**Panel Report**

**Murrindindi Planning Scheme Amendment C57 and  
Planning Permit 2016/2**

**1274 Whittlesea-Yea Road, Kinglake West**

**27 March 2017**

Figure 1 Exhibited site plan

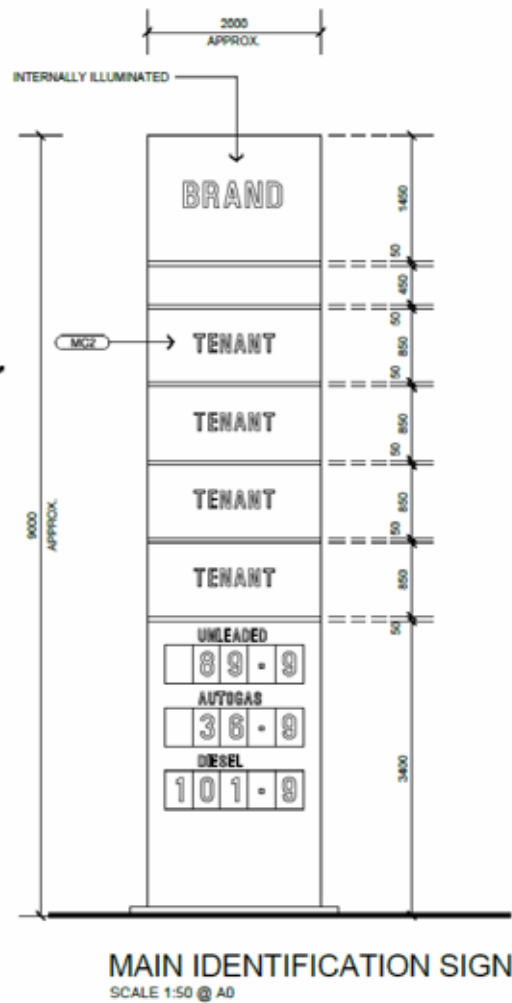
The Panel noted that the exhibited plan did contain the location of the LPG tank however the Revision E plans do not. The tank should be shown on the plans.

The Panel noted there was an error on the Revision E plans that showed the egress driveway increase its level of cut into the land on a decline in the topography, not on an incline. The levels on the site plan indicate that from the Whittlesea-Yea Road, the driveway rises and then falls down to the building envelope pad. This driveway is located 7.5 metres from the boundary to the residence further south. The Panel suggested at the hearing that, firstly there seemed to be an error in the plans (as above) and, secondly that it would be more appropriate to cut the driveway into the land so that it sits lower in the landscape than the residential property to the south and assist in providing a visual and acoustic screen to the residential property to the south. The Panel notes that the proponent and Council were supportive of this and has recommended a condition that this accessway not be lower than RL 510.35 metres.
